Technical Service Bulletin

Topic	Creaking From the Rear of the Vehicle - Diagonal Strut Brace Bolt Loose
Market area	Bentley: worldwide (2WBE),China 796 VW Import Comp. Ltd (Vico), Beijing (6796)
Brand	Bentley
Transaction No.	2076757/3
Level	EH
Status	Released for publishing
Release date	Oct 29, 2025

25MY Continental GT & Flying Spur

Figure 1

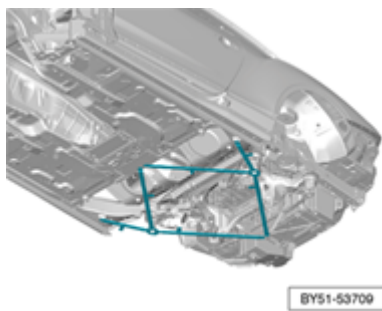
The source of the banging noise is the diagonal strut brace (Figure 1)

Figure 2

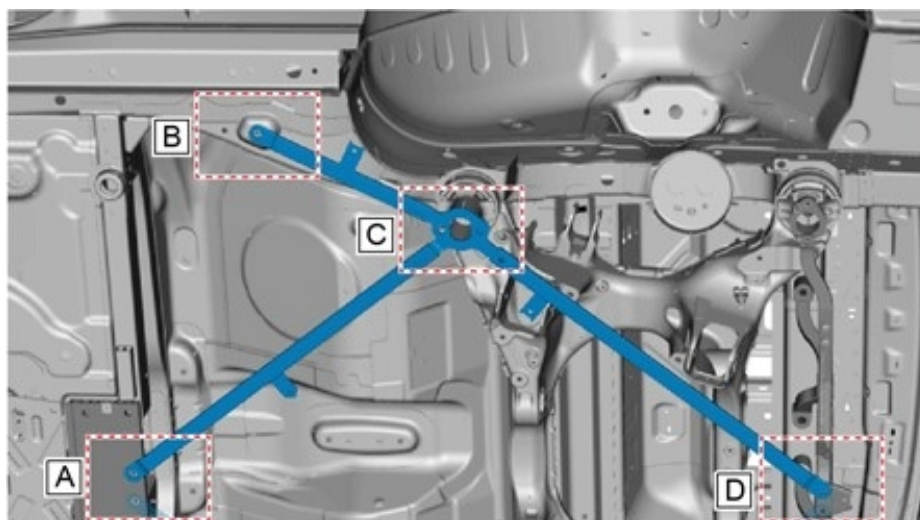
The bolts on either side, highlighted in box B (Figure 2) are coming loose and causing the noises from the diagonal strut brace.

New part used in production.

Figure 3

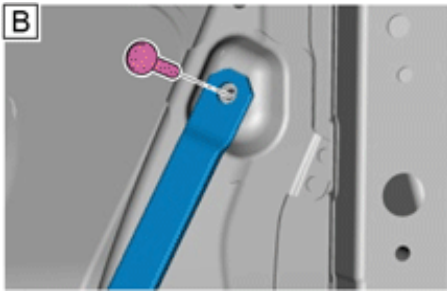
1) Check the torque value of bolt "B", highlighted in Figure 3, on BOTH sides of the vehicle. Refer to ElsaPro, Repair group 51 "Diagonal Strut Brace – To remove and fit".

NOTE: Do NOT remove the full diagonal strut brace.

2) If the bolt is not within the specified torque this could be due to contamination. Remove the bolt and replace with the new bolt (see parts information).

Before replacing the bolt ensure the thread is cleaned to remove any wax.

Ensure the bolts are torque tightened to the specified torque.

New part number for bolt “B” – N.909.210.02
